Traffic Calming (Speed Humps) - Genthorn Avenue

Date: June 18, 2026

To: Etobicoke York Community Council

From: Director, Enforcement and Street Management, Transportation Services

Attachment 2: Speed Hump Locations Plan - Genthorn Avenue

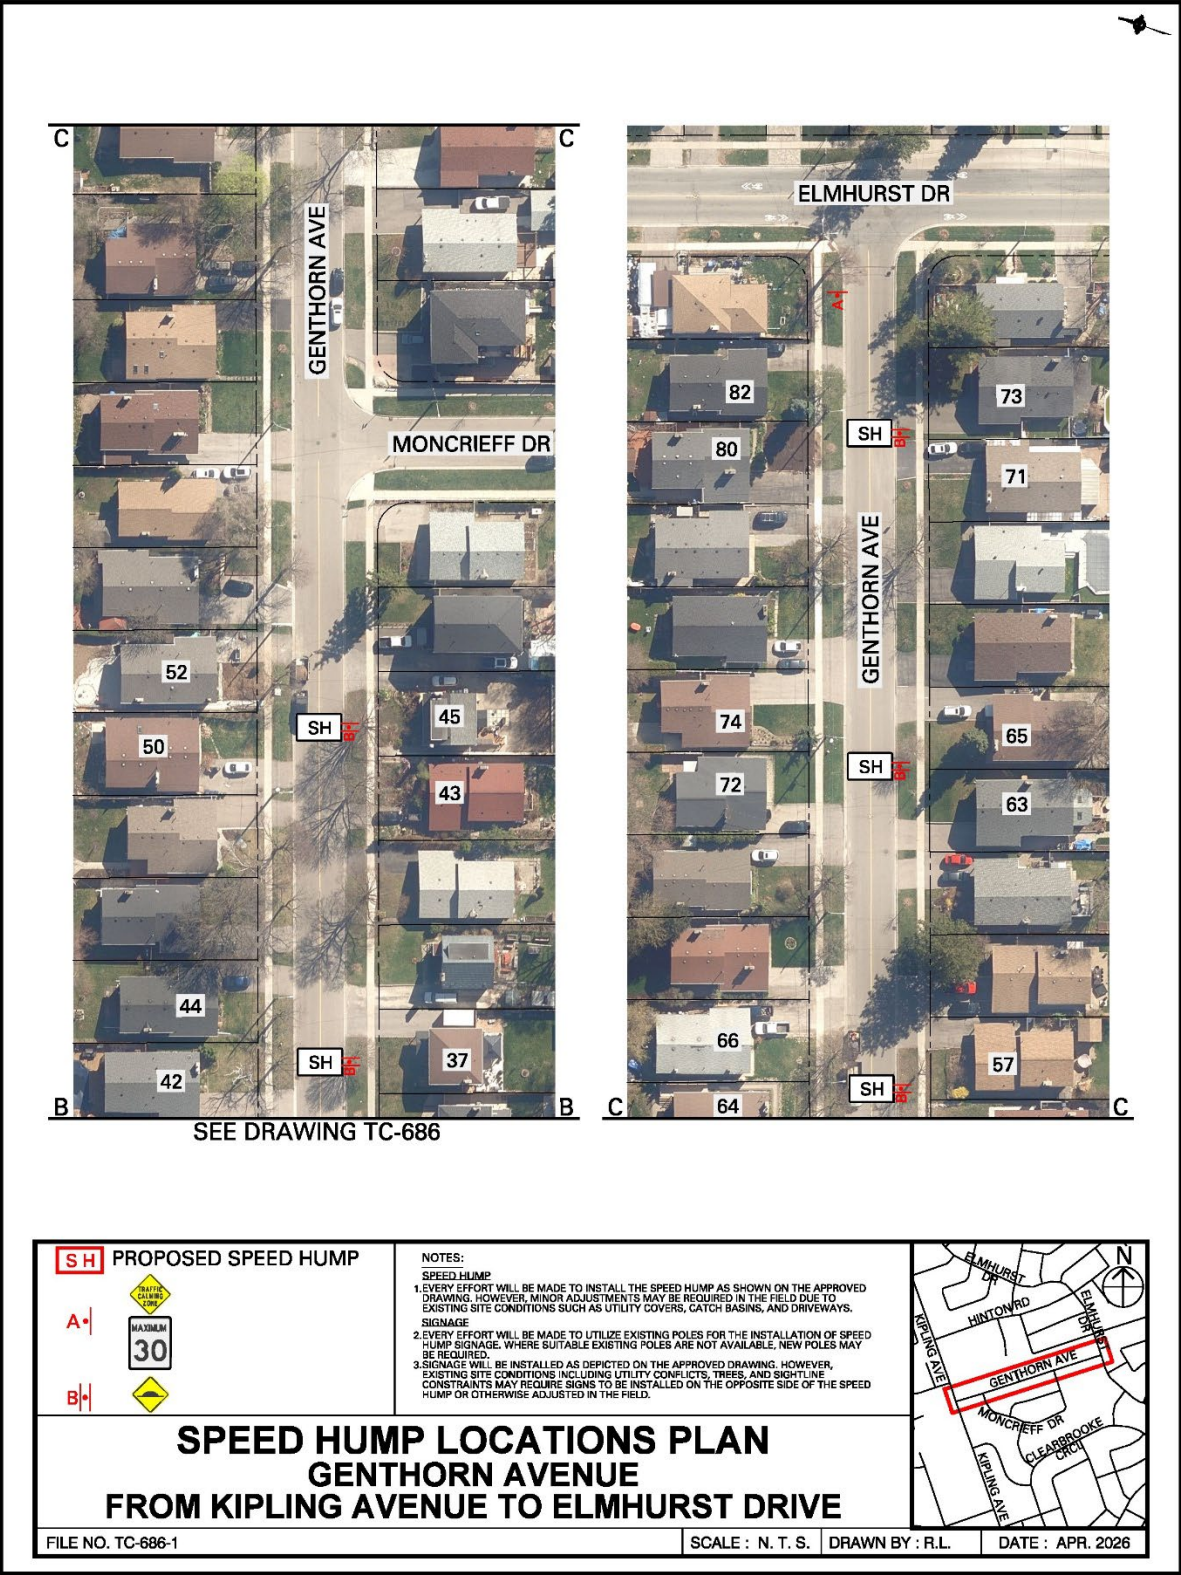
We have received and reviewed the proposal for installation of speed humps on Genthorn Avenue, between Kipling Avenue and Elmhurst Drive, with the following comments:

The installation of speed humps on Genthorn Avenue, between Kipling Avenue and Elmhurst Drive, will impact response and transport times for residents that reside on the roadway speed humps are installed. Impacts may extend to community members if Genthorn Avenue, between Kipling Avenue and Elmhurst Drive, serves access to other roadways. It is important that the applicant understands that the installation of traffic calming devices will reduce the speed that emergency vehicles travel when responding to emergencies on roadways where they are installed.

Toronto Paramedic Services responded and have advised they are not opposed to the installation of speed humps. However, it may negatively impact their service delivery. A copy of their full response is included in Attachment 3.
